#PLN-2023-163
**1501 Carlemont Drive – Rezoning, Preliminary PUD,
Preliminary Subdivision and SUP**
Project Review for Planning and Zoning Commission

| <u>Request:</u> | <ol style="list-style-type: none">1. Rezoning from R-2 PUD Single-Family Residential to B-2 PUD General Commercial2. Preliminary Planned Development for a four-lot commercial development and car wash3. Preliminary Plat of Subdivision4. Special Use Permit for a car wash |
| <u>Location:</u> | 1501 Carlemont Drive |

OVERALL ARCHITECTURAL SITE PLAN

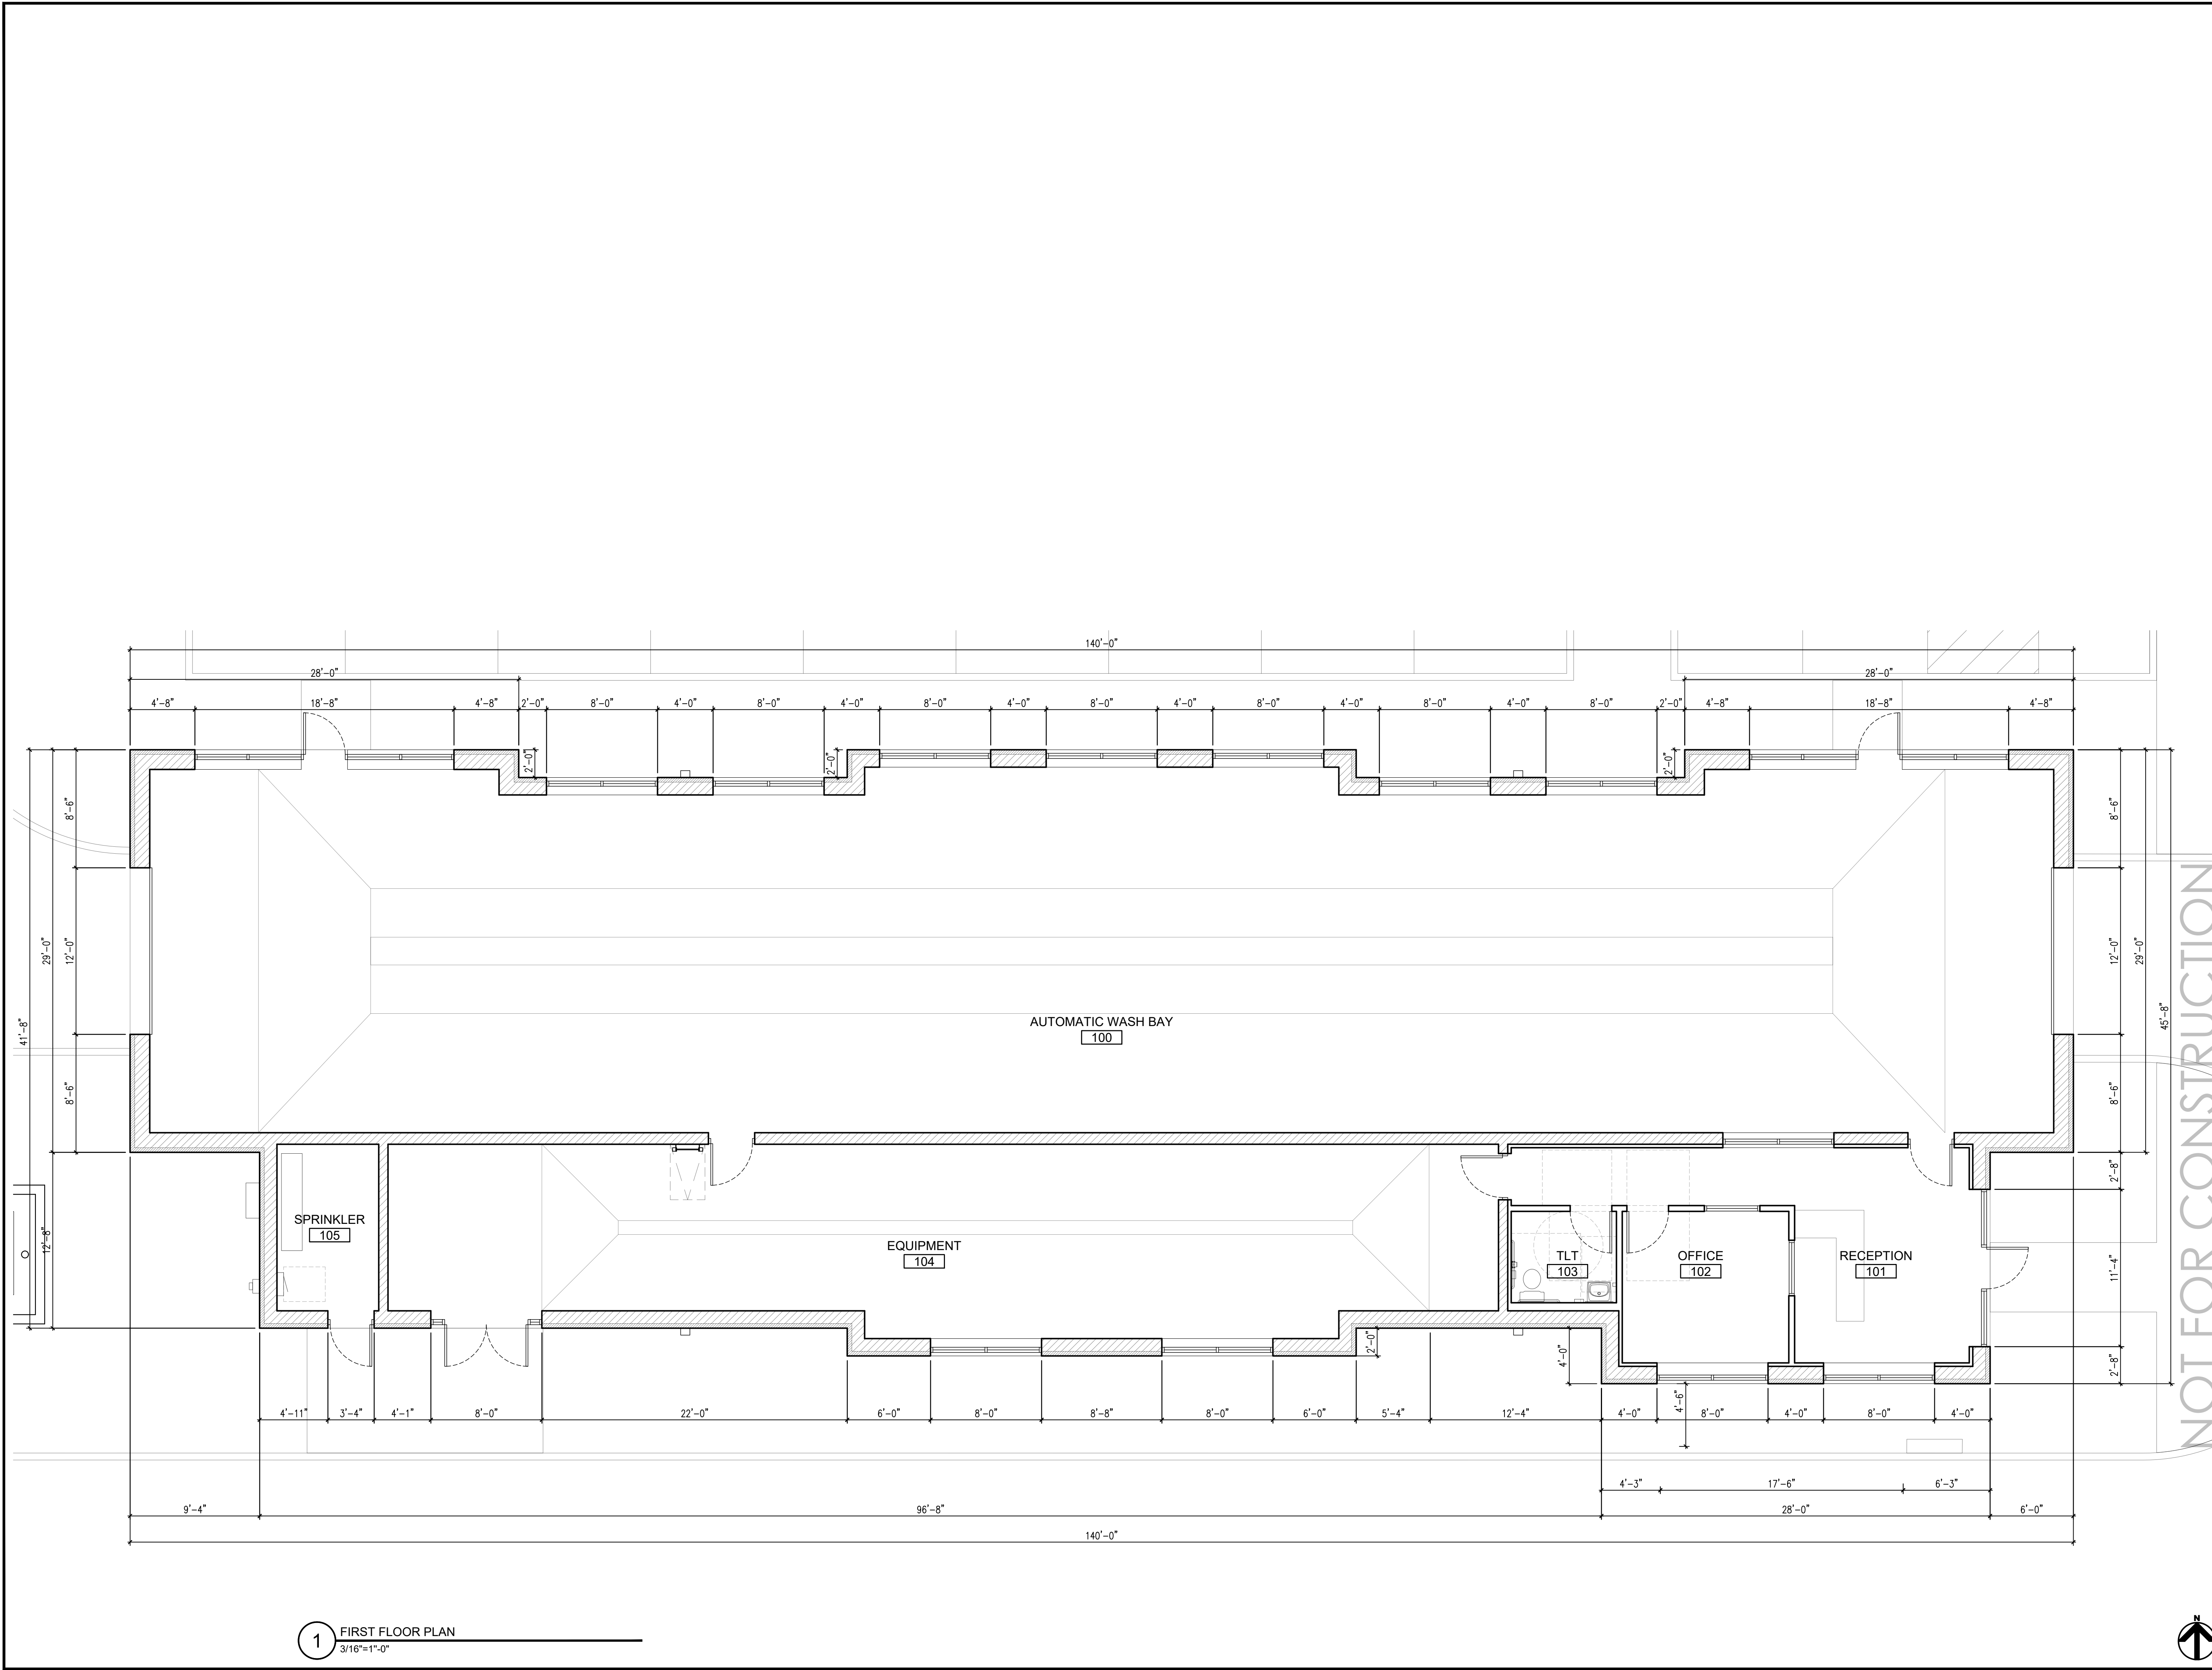
- Proposed Lots 1, 3 and 4 comply with the required setbacks for the B-2 zoning district.
- Proposed Lot 2 (car wash) complies with all required setbacks except the front yard setback. The minimum front yard setback along Randall Road is 80 feet. The proposed front yard setback is:

- 69'-6" from the proposed modified property line per MCDOT
 - 74'7" from the existing property line
- McHenry County Division of Transportation (MCDOT) has planned improvement along Randall Road from Ackman Road in Crystal Lake to Acorn Lane in Lake in the Hills. This improvement will widen Randall Road to three (3) lanes in each direction with intersection improvements. A new traffic signal will be added at Randall Road and Alexandra Boulevard. A multi-use path will be installed on the east side of Randall Road and a sidewalk on the west side. Right-of-way is needed for the County's improvement along the frontage of this development, thus resulting in a modified property line.

The proposed front yard setback for the car wash building is 69'-6" from the proposed modified MCDOT property line and 74'-7" from the existing property line. With the modified property line, the petitioner loses approximately 5 feet, thus increasing the variance.
